- A. Drive Shaft Housing Oil Seal Installation Tool for MerCruiser I Models
- B. Water Pump Base Oil Seal Installation Tool for MerCruiser I Models
- C. Special Tap for Installing New Style Shift Cable on MerCruiser I Models

CIRCULATE TO:  
 SERVICE MANAGER   
 PARTS MANAGER   
 MECHANICS   
 "Place in a Service  
 Bulletin Binder"

**Figure 1. Installing Drive Shaft Housing Seals**

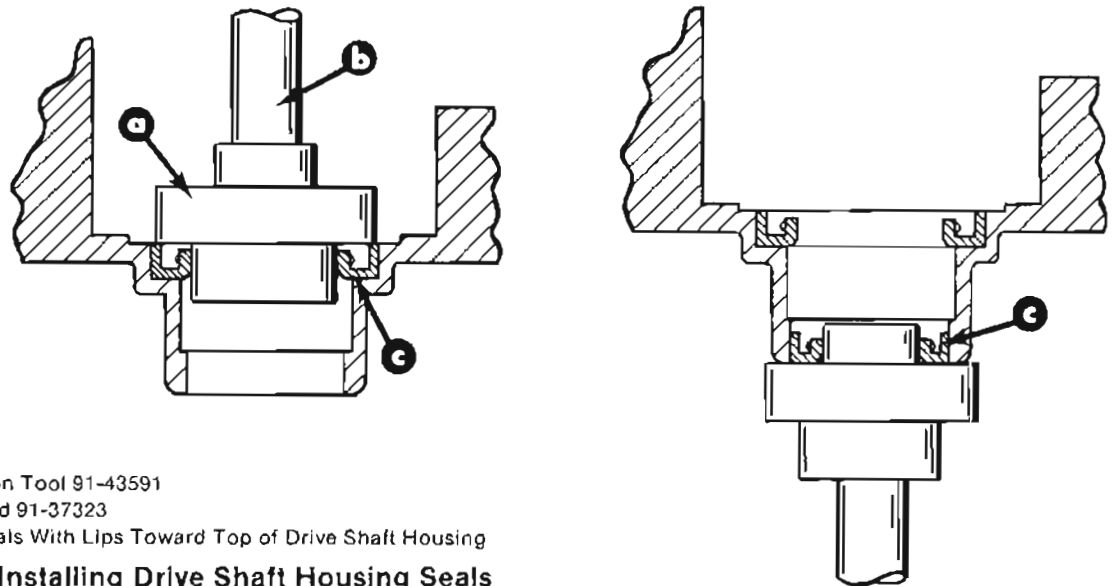
A new Oil Seal Installation Tool, 91-43591, is now available for installing the upper drive shaft oil seals in the drive shaft housing. (Figure 1) The new tool can be used on all MerCruiser I models and replaces Oil Seal Driver, 91-56032, which is no longer available.

- a - Installation Tool 91-43591
- b - Driver Rod 91-37323
- c - Install Seals With Lips Toward Top of Drive Shaft Housing

**Figure 2. Installing Oil Seals In Water Pump Base**

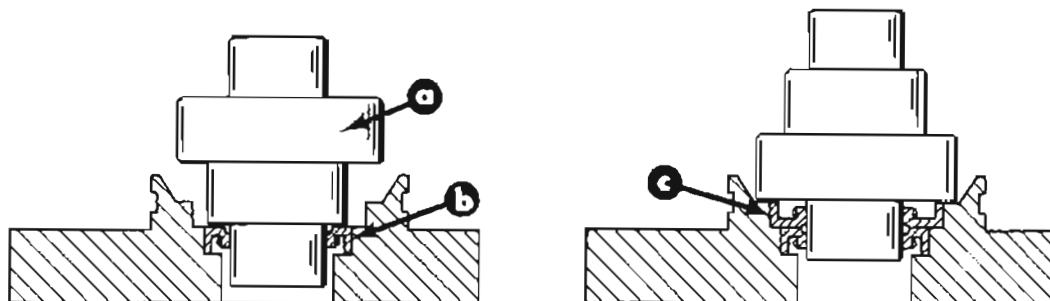
An Oil Seal Installation Tool, 91-44110 is now available for installing oil seals in the water pump base. (Figure 2) This tool will work on all MerCruiser I models and all 75 HP and above Mercury/Mariner models.

- a - Installation Tool 91-44110
- b - Install Upper Seal With Lip Toward Water Pump
- c - Install Lower Seal With Lip Toward Gear Housing

Figure 3. Tapping Threaded Hole In Bell Housing

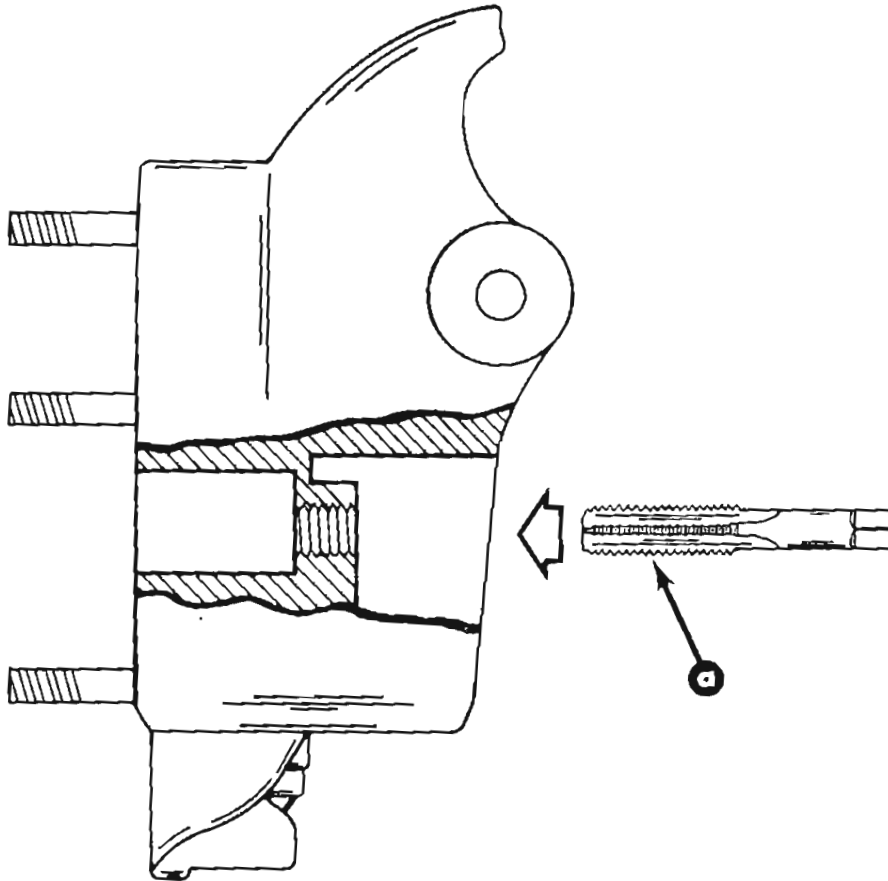
MerCruiser 120R-thru-260R drive unit shift cable, 41951A1 (which attaches to bell housing from aft end) can be used on older MerCruiser I models. To do this, threaded hole in bell housing must be tapped all-the-way thru, using a  $\frac{1}{4}$ -18 NPSF tap. (Figure 3) This special straight thread tap may be difficult to obtain in some areas, therefore, Mercury Marine will now offer it under part number 91-95639. The following important information must be observed when performing tapping operation:

- Tapping must be done from the front (bellows) end of bell housing to prevent cross-threading.
- Never use a tapered thread tap as improper positioning of shift cable may result.

a - Tap 91-95639
